Drawing Title: Comparison of west elevation

Job No: 2502 | Drawing No: SK03 | Rev: A

Job Title: 33 West Front Road, Pagham

Rev	Date	Revision Details	Dr	Ch
A	18.08.26	For discussion with Planning Officer	DH	AD

4. New application to be submitted as Removal/Variation of Condition application (1:125)

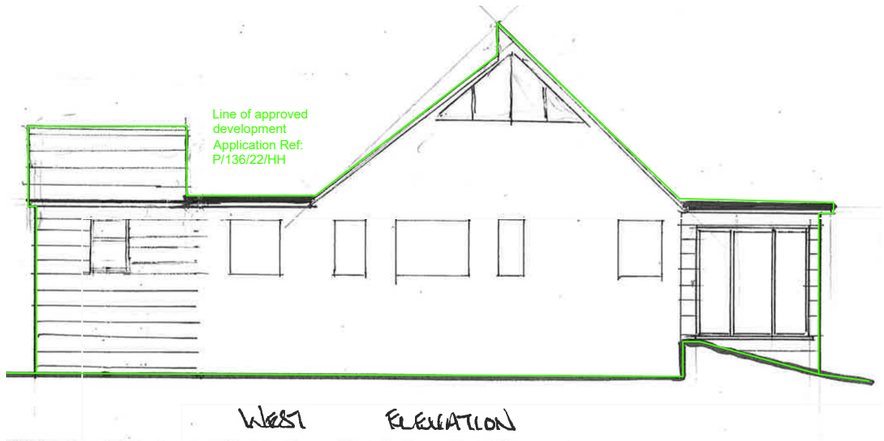
Our proposal retains the existing ridge height and consolidates the overall building mass which respecting what currently exists on the site. Most importantly, allowing the clients to reveal and restore the train carriages internally.

Our proposed elevation also reduces the size of windows and shows the new external cladding and insulation to make the house more thermally efficient.

2. Proposal as drawn in granted scheme (1:125)

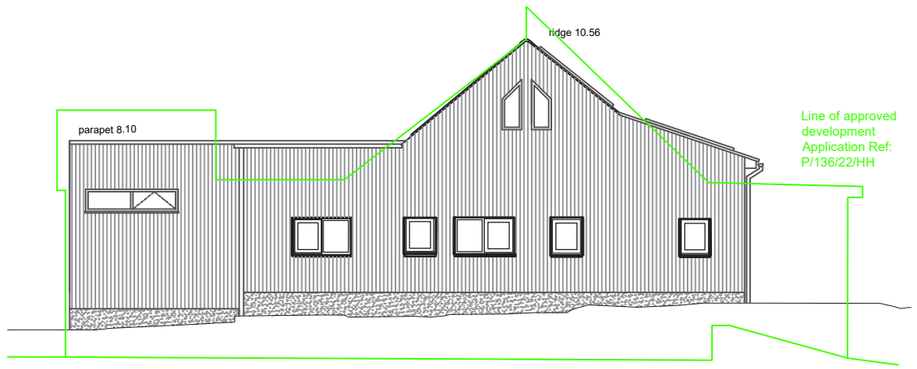
No levels on the proposal. But the granted scheme increases the ridge height and introduces extensions that look bolted in - not coherent or considered.
